TECHNICAL BULLETIN

Steering Rack – Surface Cracks – Service Action S450

57-20
Amended
8/95

MODEL XJS (4.0L) Range 1995 MY

ILLUSTRATION 1

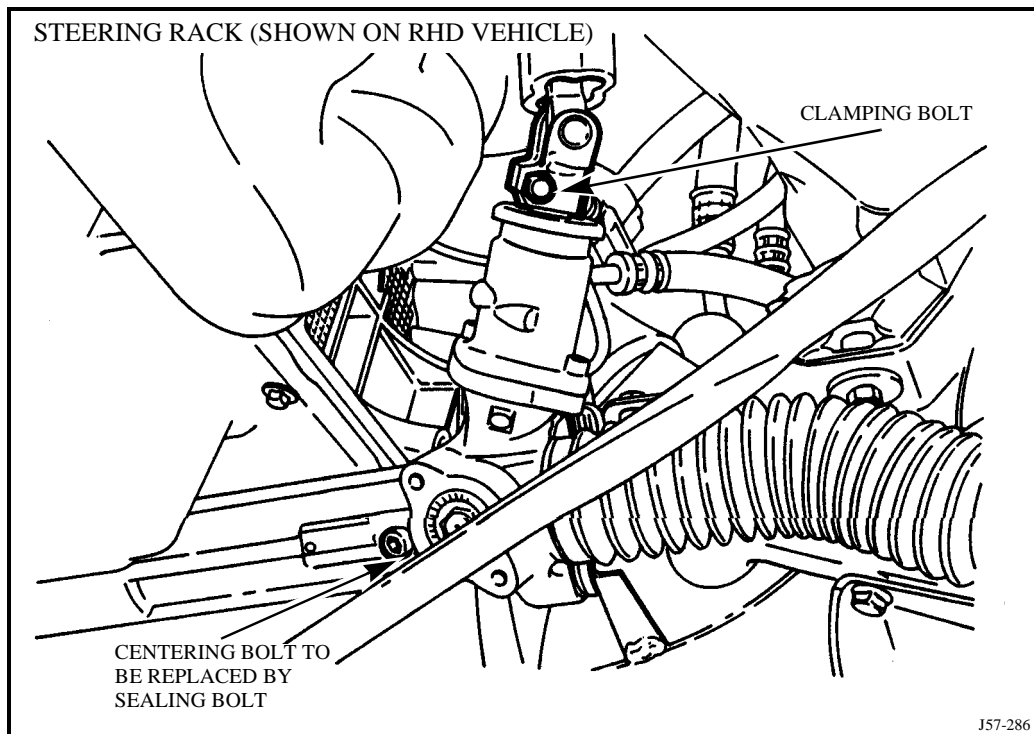
4. Remove the clamping bolt and nut that attach the steering shaft to the pinion, Illustration 1.
5. Turn the ignition key to position 1 and turn the steering wheel to the straight-ahead position. Turn the key to the OFF position and remove.

- Insert the clamping bolt and nut (Illustration 1) and tighten to 17.702 - 22.127 lb ft (24 - 30 Nm).
- Connect the supply and return hoses.
- Connect the tie rod ends to the steering arms and tighten to 44.991 - 50.892 lb ft (61 - 69 Nm).
- Remove the centering bolt and replace it with the sealing bolt (JZS 100046) and washer (JZW 100019), Illustration 1. Tighten the bolt to 4 - 5.25 lb ft (5.5 - 8.5 Nm).
- Refill the steering system, reconnect the battery, run the engine and turn the steering wheel from lock to lock to purge the air from the system. Check the fluid level.
- Check/adjust the front wheel alignment.**
- Reset the clock.
